508-510 BOOKER ALLEY – NARRATIVE

Requesting final approval to construct a two and a half story house with a two story detached garage on a vacant lot.

Responses to previous design staff comments:

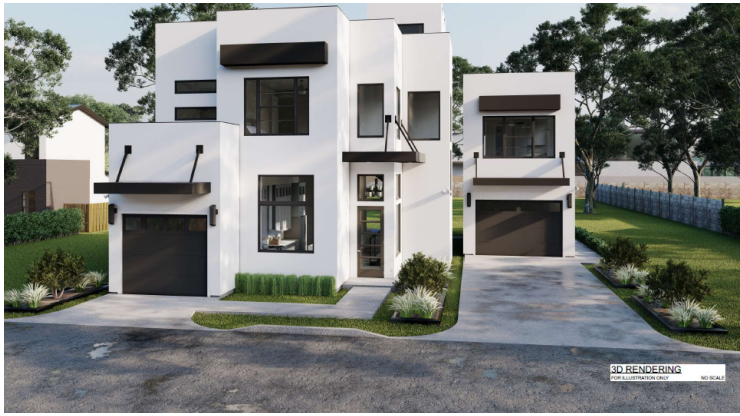
- i. That the proposed new construction features a front setback that is equal to or greater than the side setbacks of the two structures that are adjacent to the alley, addressed as 512 N Cherry and 515 N Mesquite, and one that is greater than the new construction that fronts the alley at the rear of the lot addressed as 511 Dawson. The applicant is responsible for submitting a setback diagram to confirm appropriate setbacks. A foundation inspection is to be scheduled with OHP staff to ensure that foundation setbacks and heights are consistent with the approved design. The inspection is to occur after the installation of form work and prior to the installation of foundation materials. ***Essentially what this is saying is that the new construction needs to generally fit within the green box shown below. This is drawn for visual reference and doesn't negate side and rear zoning setbacks.***

- ii. That a foundation height that is consistent with the Guidelines be installed. ***Foundation heights in the immediate vicinity appear to be between 1 and 2 feet in height. Below are a few new construction examples of what this would look like.***

- iii. That roof forms that are found historically within the district be incorporated into the design; primarily gabled or hipped roof forms. ***There are multiple historic structures within the immediate vicinity of the proposed new construction that feature gabled and hipped roofs. Flat roofs are not found historically on this block. The proposed flat roofs are not consistent with the Guidelines, and staff finds that roof forms that are found historically within the district should be incorporated into the design; primarily gabled or hipped roof forms. Below is a photo of adjacent, historic roof forms. I've also provided examples of new construction that have successfully incorporated historic roof forms into their design.***

- iv. That an accurate calculation of both structure's footprints be submitted, and that footprints should not be greater than fifty (50) percent of the total lot area. ***Building footprints, including unconditioned porch, patio, and garage space should be included. Footprints of new construction should be limited to no more than fifty (50) percent of the total lot area, unless adjacent historic buildings establish a precedent with a greater building to lot ratio.***

- v. That materials and their profiles and details, should reflect those found historically within the Dignowity Hill Historic District, and should be incorporated into the design. The proposed stacked stone and predominance of stucco should be eliminated. ***Historically, residential structures in the district feature wood siding in a lap profile. At times, board and batten are also appropriate. The proposed stucco should be eliminated for siding (you can use composite siding provided that it does not feature a faux wood grain texture/finish).***

- vi. That windows that are consistent with the adopted standards for windows in new construction should be installed. These specifications are noted in the above applicable citations. ***I can provide specific window information again, if needed.***

- viii. That the proposed structure's massing be modified to feature traditionally positioned and massed porch elements. ***Below are two photos; the first is of a historic houses' porches and the second is of new construction which comparably incorporates the porch massing into the new construction. The porch should be incorporated into the whole massing and design, not simply a stoop with a canopy or awning.***

- ix. That architectural elements that are both consistent with the Guidelines and historic examples found within the district should be incorporated into the design. There are numerous elements of the proposed design that staff finds to be inconsistent with the Guidelines, such as the proposed commercial style canopies and awnings, the lack of a

front porch that is integrated into the massing of the house, and the alternating masses and forms that generally makes the proposed design fall outside of what architecturally would be consistent with historic structures found within the historic district. ***I believe this has been addressed in the various comments above, but if not, please let me know and I can clarify.***

A setback diagram was added to the exhibits to show the adjacent historic setbacks. The proposed front setback was modified so that the new house is set behind the side setbacks of both historic structures at the corners (512 N Cherry and 515 Mesquite) and in line with the non-historic ADU at 511 Dawson.

A foundation height exhibit was added to our application. This exhibit shows foundation heights along Booker Alley to be between 12-18in. The proposed 12in is within one foot of the adjacent foundation heights as recommended by the guidelines.

The proposed flat roof has been modified to a gable roof except for a small portion in the rear of the structure that will serve as a mechanical area.

The proposed building footprints have been adjusted to fit within the allowed 50% lot area. Calculations have been added to sheet SP100.

Although the majority of residential structures within the neighborhood have wood siding, there are some examples of historic plaster and new construction using stucco. Both the neighboring ADU and main house at 511 Dawson are stucco. The proposed stucco will have a smooth finish and will be painted so that it is consistent with other stucco/plaster installations found in the district.

Fenestration pattern was updated throughout to be more consistent with the guidelines. Specifications for windows and a wall section has also been included in the drawings.

The proposed front elevation has been revised to incorporate a front porch.

All elevations have been revised throughout to incorporate a more appropriate massing and form, incorporate a front porch and to make it overall consistent with the guidelines.
